Port Hills Geotechnical Group
Assessment of GNS Model Applicability for Cliff Collapse Risk

Sector: 1 Address: 88 BULLOCK BAY

Port Hills Geotechnical Group
s124 (geo) Notice Decision Process - Cliff Collapse

Address of property: 1 BOULDER BAY

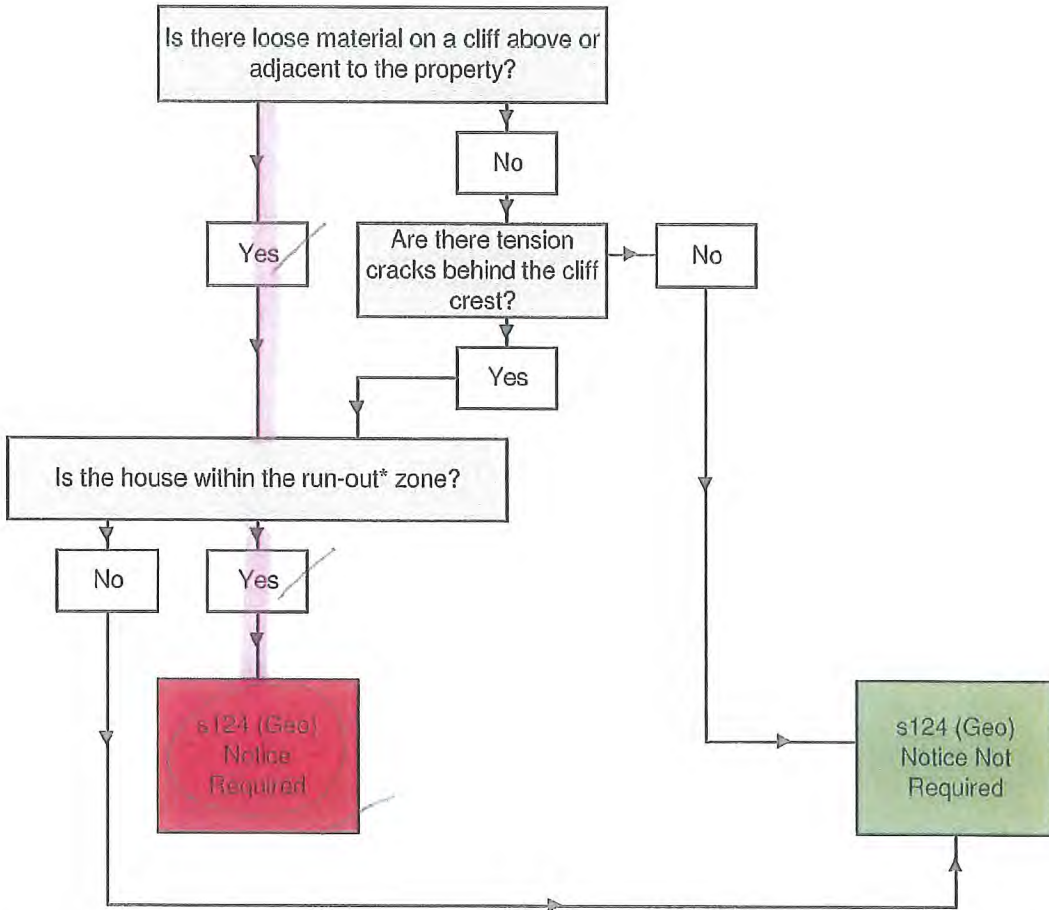
Comments: TENSION CRACKS IN SLOPE DIRECTLY ABOVE PROPERTY.

- The property at 1 Boulder Bay is situated at the base of a cliff.
- Portions of the cliff adjacent to the dwelling collapsed as a result of both the 22 Feb and 13 June 2011 aftershocks.
- At least two boulders fell from the cliff and landed within 10m of the dwelling
- Several small collapses of the cliff face behind the house were observed following the 22 Feb and 13 June 2011 aftershocks.
- Tension cracks are present on the cliff situated behind the property.
- There is a potential for further failure of the cliff in this area.

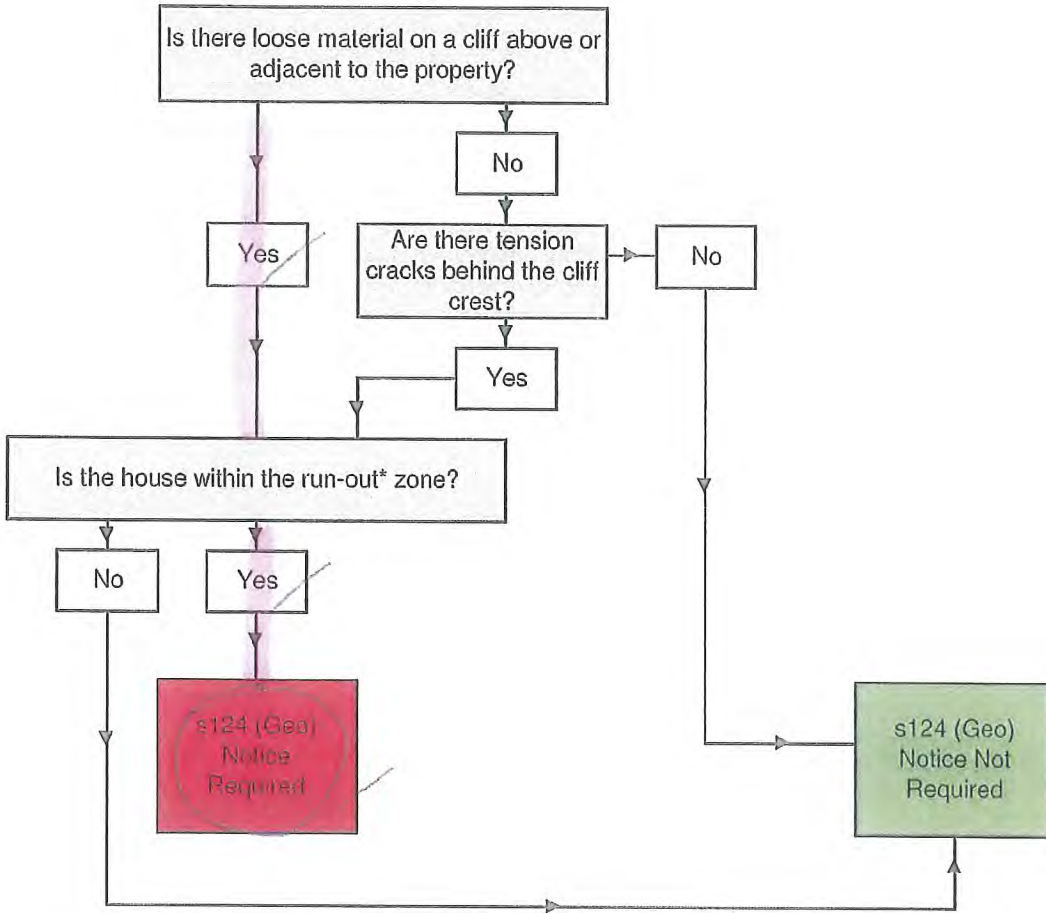
Comments:
S124 in place already
tension crack at cliff crest

TENSION CRACKS IN SLOPE DIRECTLY ABOVE PROPERTY
